Kewaunee Nuclear Power Plant
 N490, State Highway 42
 Kewaunee, WI 54216-9511
 920-388-2560

DOCKET 50-305
 OPERATING LICENSE DPR-43
 KEWAUNEE NUCLEAR POWER PLANT
NUCLEAR MANAGEMENT COMPANY, LLC. RESPONSE TO NRC 'S REQUEST FOR
 ADDITIONAL INFORMATION ON WISCONSIN PUBLIC SERVICE CORPORATION
 RELOAD SAFETY EVALUATION METHODS TOPICAL REPORT, WPSRSEM-NP,
 REVISION 3

Response to NRC Questions Concerning Reload Safety Evaluation Methods

FIGURE 1

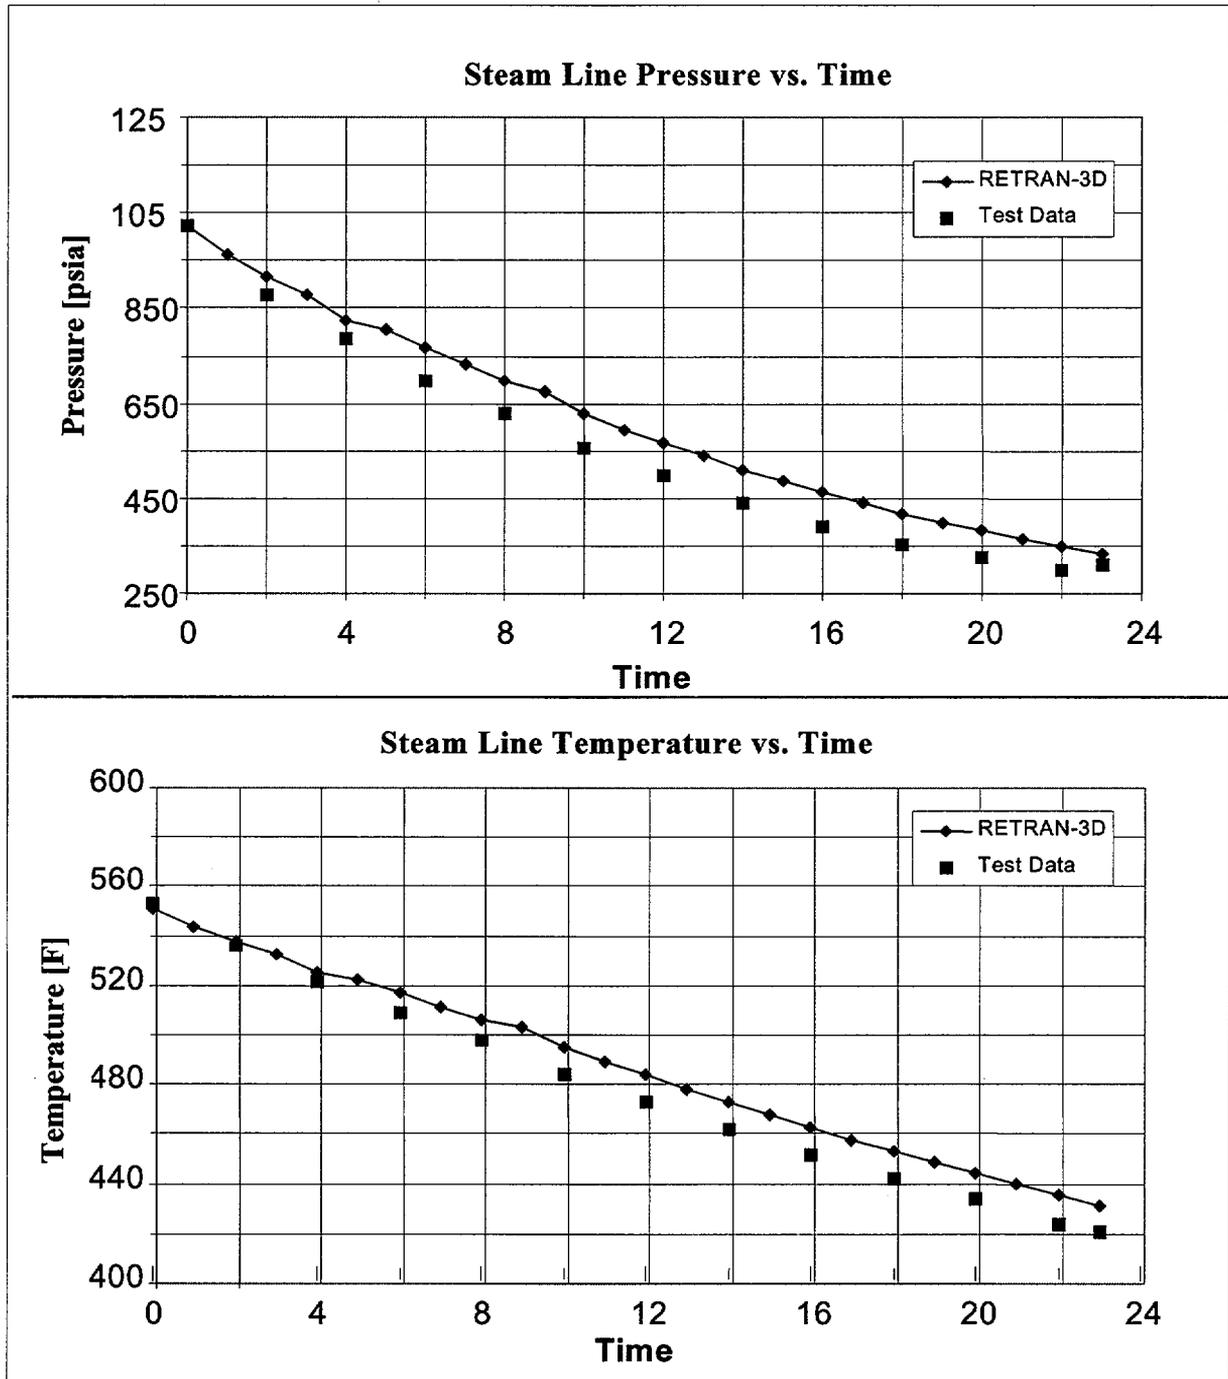
Figures 1 through 4 compare the pressure and temperature responses for runs 109,112,116,and 119 respectively. These comparisons show good overall agreement of the calculated results with the measurements.

Figure 5 – CE Test Rig RETRAN Noding Diagram
(not to scale)

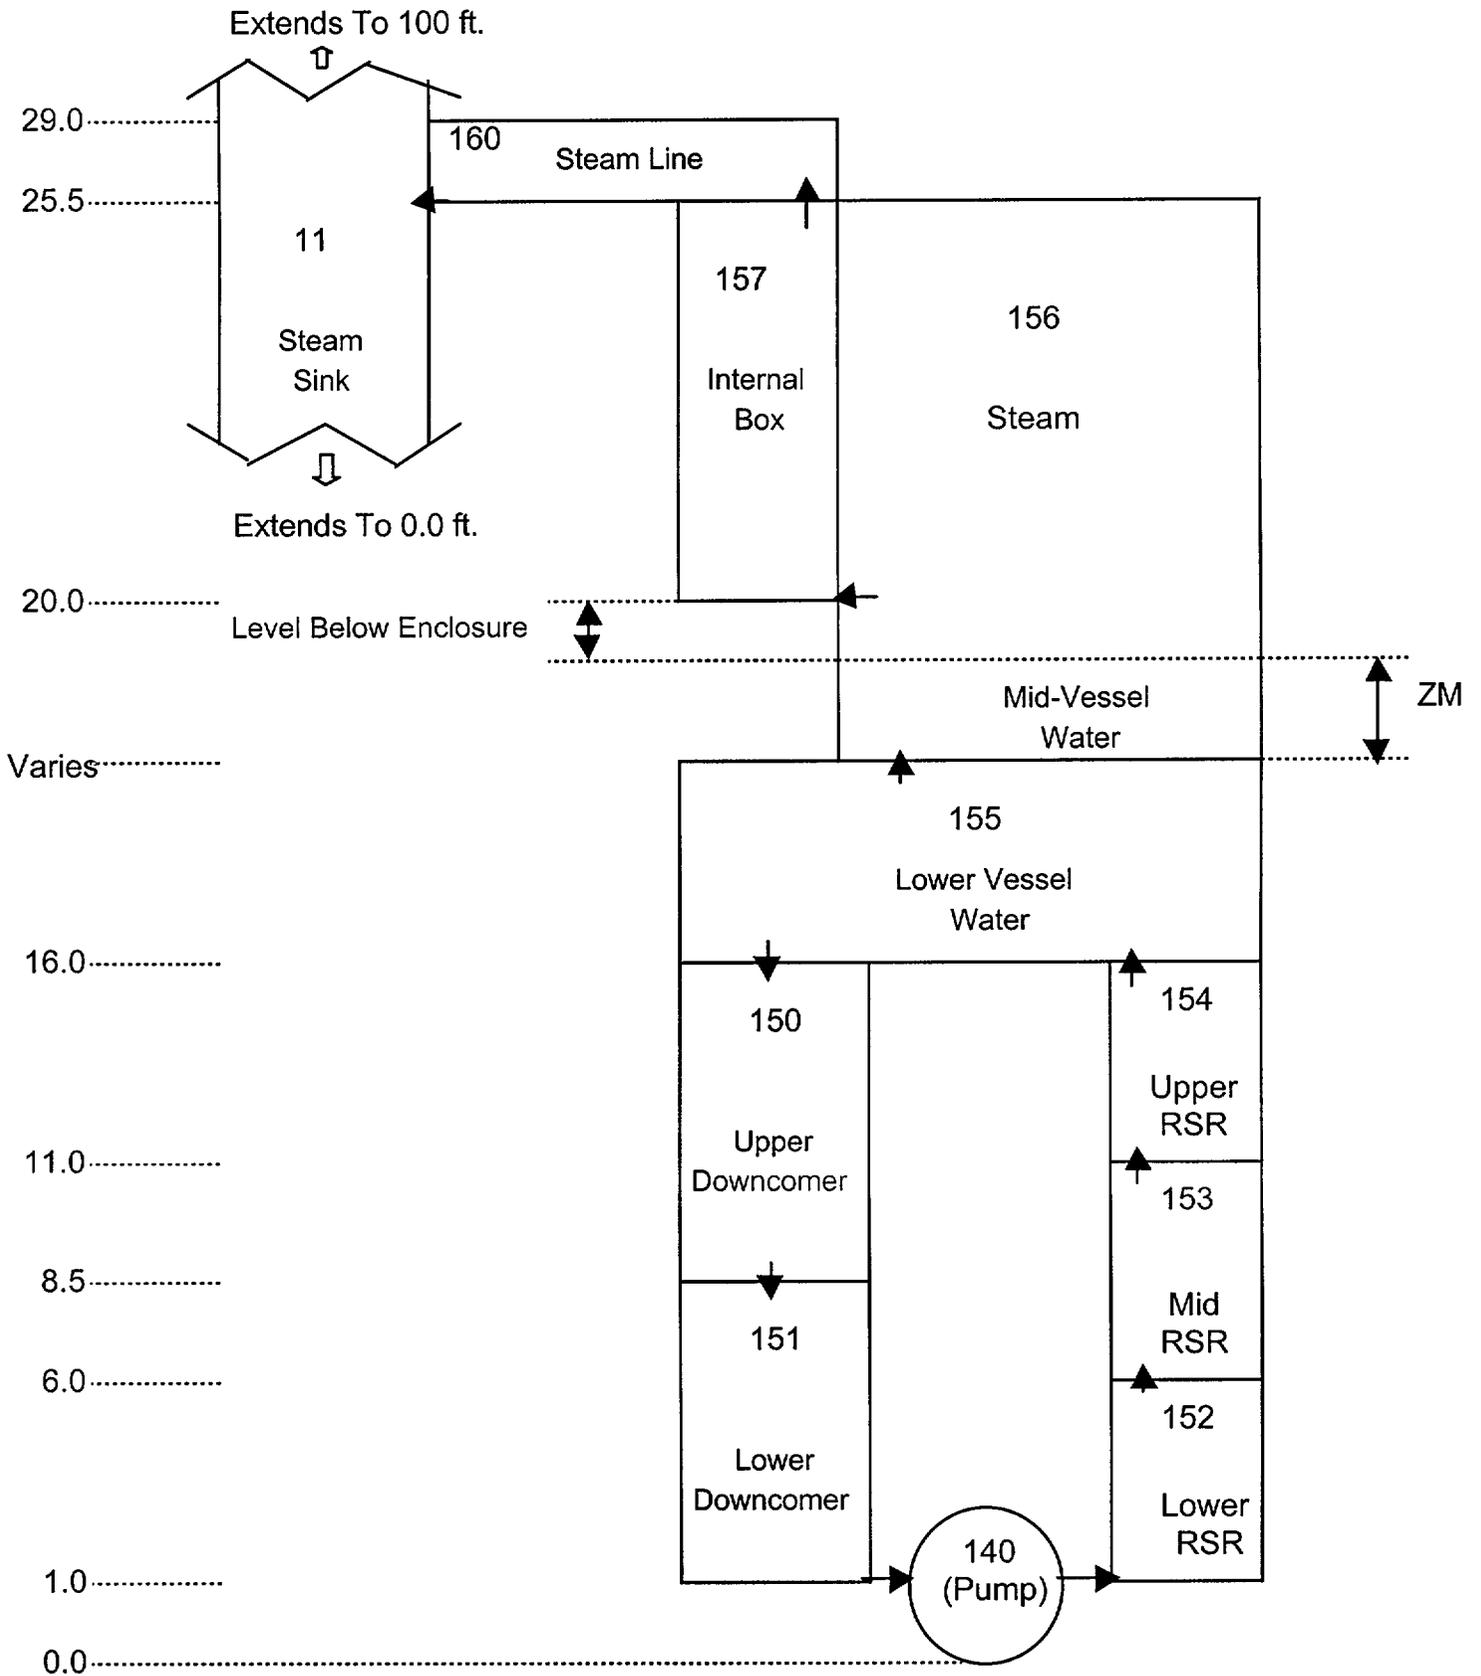
2.3.2 *A drawing showing the RETRAN 3-D steam generator noding used for the experiment(s) and the Kewaunee steam generator*

Figure 5 and 6 show the RETRAN-3D model steam generator noding used for the experiments and for KNPP steam generator respectively.
